Application Number:	PL/2026/00617
Location:	Land off junction of Salisbury and Lynchets Roads, Amesbury, SP4 7JA
Proposal:	Creation of a permanent layby, bollards and a temporary compound access off Salisbury Road, Amesbury to enable construction and future operation of a below ground stormwater storage tank.

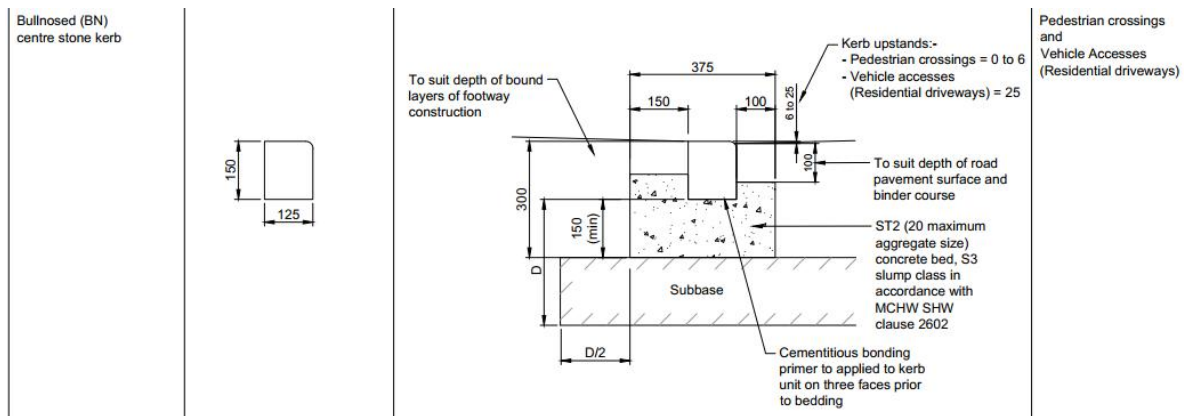
The agreement to the principle of the proposal had been the subject of a pre-application submission, with a proposed temporary access located approximately 70 metres southeast of the junction of the A345 with Lynchets Road.

The submitted plans with the current planning application now indicate the proposed temporary access to be located much further south, approximately 130 metres from the junction with Lynchets Road. This location indicates an access which would require vehicles to make a 180-degree turn into the site to access the compound, resulting in unacceptable manoeuvring on the A345. An access which is formed perpendicular to the A345 carriageway would be required, which should include the required 2.4m by 43m visibility splays.

The submitted plans do not provide any detail of the size of vehicles required to access the compound, and it should be demonstrated with swept path analysis that such an access can adequately accommodate the required manoeuvres of the largest vehicle that would need to access the compound.
